RE: Project File #: PUDSP-22-004

Project Name: Sanctuary at Meridian Ranch Parcel Nos.: 42000-00-402; 42000-00-450

EXECUTIVE SUMMARY

PUD DEVELOPMENT / PRELIMINARY PLAN

Figure G.1: Placetype Map

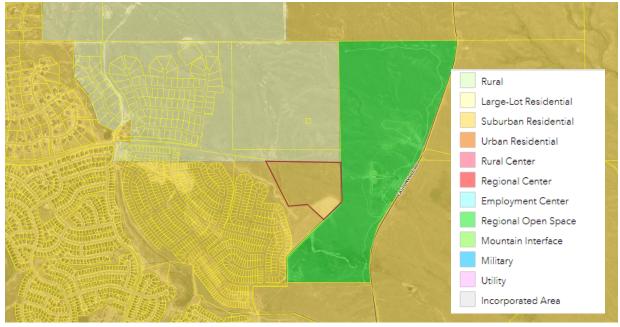
The property is located within the Suburban Residential placetype. The Suburban Residential placetype comprises the County's traditional residential neighborhoods with supporting commercial uses at key intersections in addition to multifamily developments which may provide a transition from the supporting commercial land uses to the single-family developments. Relevant goals and objectives are as follows:

Figure G.2: Area of Change Map

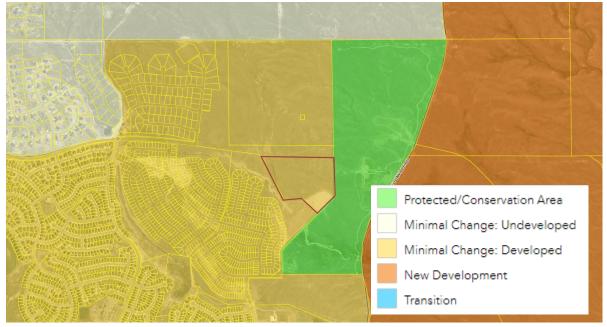
The property is located in an area which is not expected to significantly change in character due to primarily being surrounded by developed land. The level of change proposed with the PUD development plan and preliminary plan is consistent with the level of change identified in the Minimal Change: Developed Area, as the character of the area is not expected to be transformed; but rather remaining vacant lands are likely to be developed consistent with adjacent land uses. This area is adjacent to built-out areas within the Meridian Ranch development.
